1696–1758 Villa Street Residential Project

Revised Final Environmental Impact Report – Responses
to Comments Document

Responses to Comments on the Draft EIR

Figure 24 Project Trip Distribution Pattern

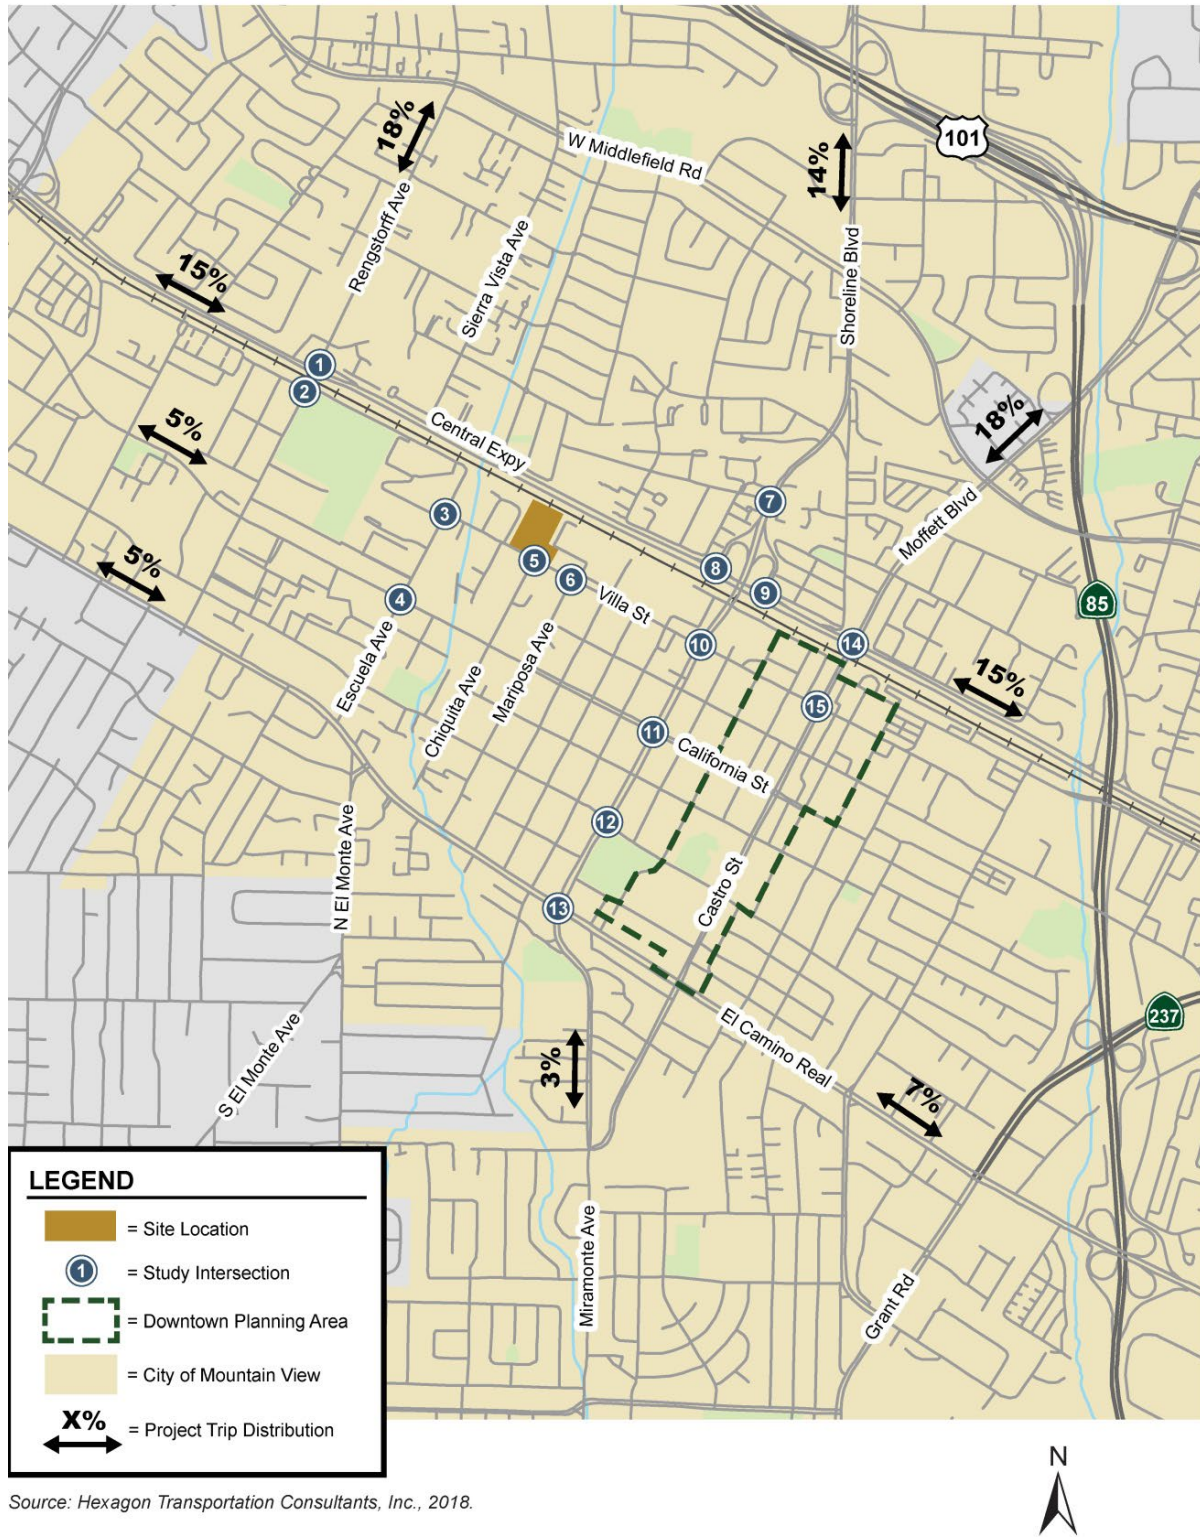
- Please ensure that the DEIR provides project trip assignment diagram as currently is missing this detail.
- Please provide construction Traffic Control Plan (TCP) for The County to review, if County facilities are used during construction.

Project trip distribution is shown on Figure 24 (Page 221) of the Draft EIR (please refer to the black arrows and percentages on this figure for the distribution along local streets) and project trip assignment is shown on Figure 8 in the project Traffic Impact Analysis which is included in Appendix L of the Draft EIR.
